**Corrigendum to “Interdependencies between physical, design and operational parameters for direct use geothermal heat in faulted hydrothermal reservoirs” [Geothermics, 86 (2020) 101806](S0375650519303785)(10.1016/j.geothermics.2020.101806)**

## Corrigendum to “Interdependencies between physical, design and operational parameters for direct use geothermal heat in faulted hydrothermal reservoirs” [Geothermics, 86 (2020) 101806]

Figure 9 Published.

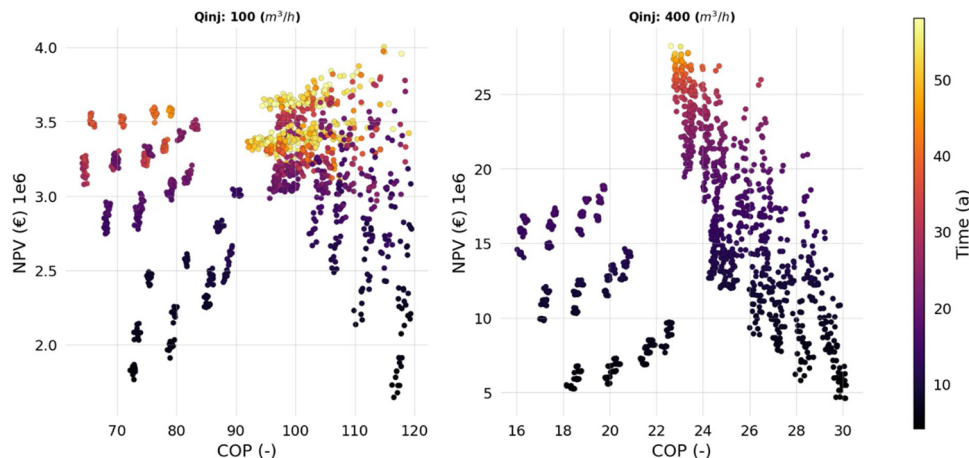
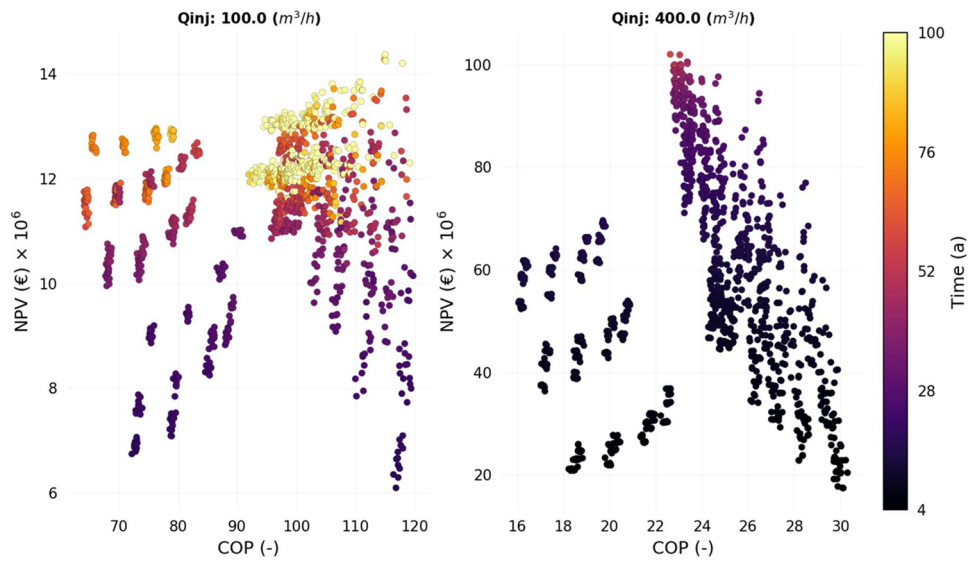
As the code was actively developed during the time of publication, the published data suffer from an error with regards to the discount factor applied during the NPV calculation. The published data NPV has been calculated for periods of 100 days, while the discount rate applied was the quoted Annual Discount Rate (ADR) value of the manuscript, namely 7%. When the NPV is calculated at intervals shorter periods than a year, the discount rate needs to be adjusted accordingly. This adjusted Periodic Discount Rate (PDR) should be calculated according to the following equation:

This was not done for the published data, due to different versions of the code being used. As a result, the time value of money was discounted much more than it should be (7% each 100 days when it should be 1.8697% per 100 days), leading to lower NPV values. This affects section 3.3 “Lifetime and NPV” of the published article (Figures 9, 10 and 11). We have re-performed the processing after having addressed this issue and plotted the corrected data in the updated figures below. While the qualitative conclusions that were drawn from the published figures are not significantly different from the corrected ones, the quantitative NPV values of the corrected figures differ substantially.

$$PDR = (1 + ADR)^{period/year} - 1$$

For our data this means that the PDR should be 0.018697 or

1.8697% for each period of 100 days for which the NPV is calculated.
